ALERT SERVICE BULLETIN

NO. 206L-03-125

SUBJECT: MAIN ROTOR BLADES 206-015-001-ALL
INSPECTION AND REWORK OF

HELICOPTERS AFFECTED: Model 206L Series

Figure 1. Area to inspect

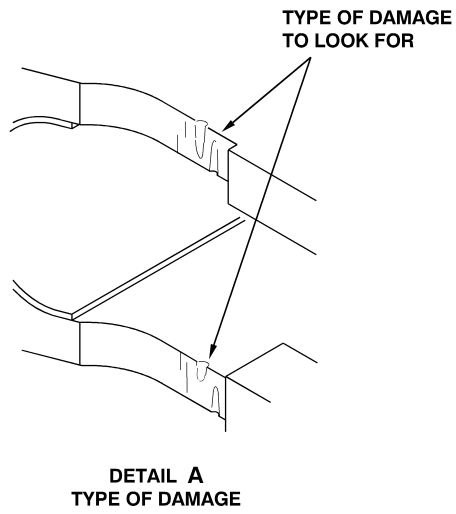
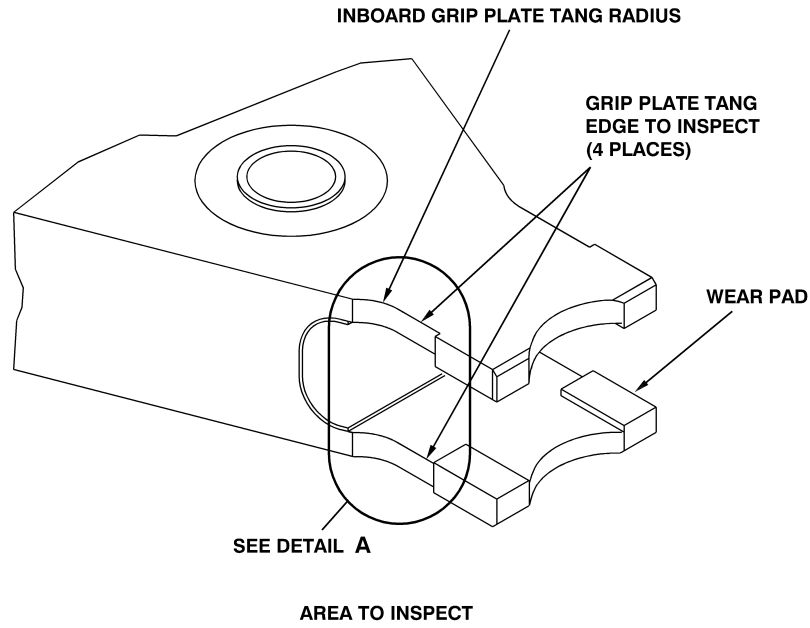
1. Inspect the blade grip plate tangs leading and trailing edges between the wear pads and the inboard radius for presence of tool marks (Figure 1). The surface should be flat, with no waves or notches (Figure 1, DETAIL A).
2. If a damage or an irregularity on the surface as shown on the Figure 1 is found do PART II of this Alert Service Bulletin.
3. If no damage or irregularity on the surface as shown on the Figure 1 is found, the blade is serviceable.
4. Using a vibrating stylus, mark ASB 206L-03-125 on the blade Modification Plate to indicate that this Alert Service Bulletin has been accomplished.

3. Measure the depth of the damage.
4. If the depth of the damage exceed 0.050 inch (1.27 mm) remove the blade from service.
5. Send the defective blade to Bell Helicopter Customer Property Return with a Malfunction Report attached with the ASB number in reference.
6. If the depth of the damage is at 0.050 inch (1.27 mm) or less do PART III of this Alert Service Bulletin.

1. Using a single cut general purpose half round file No 2 or 3 (smooth cut) blend smooth the damages in a ratio of 10 to 1. As an example, if the damage is 0.040 inch (1.5424 mm) deep, blend 0.400 inch (15.24 mm) on each side of the damage. The maximum depth after rework is 0.050 inch (1.27 mm).
2. After blending with the file, polish the surface with 180-220 grit Aluminum Oxide Fabric Cloth to obtain a finish of 63 RMS.
3. Thoroughly clean the reworked area with solvent (C-309) or (C-316).
4. Apply a chemical film treatment of Alodine 1200 (C-100) to the bare metal surfaces.
5. Apply a coat of Polyamide Epoxy Primer (C-204) and two coats of Polyurethane paint color # 37038 (C-245).
6. Using a vibrating stylus, mark ASB 206L-03-125 on the blade Modification Plate to indicate that this Alert Service Bulletin has been accomplished.
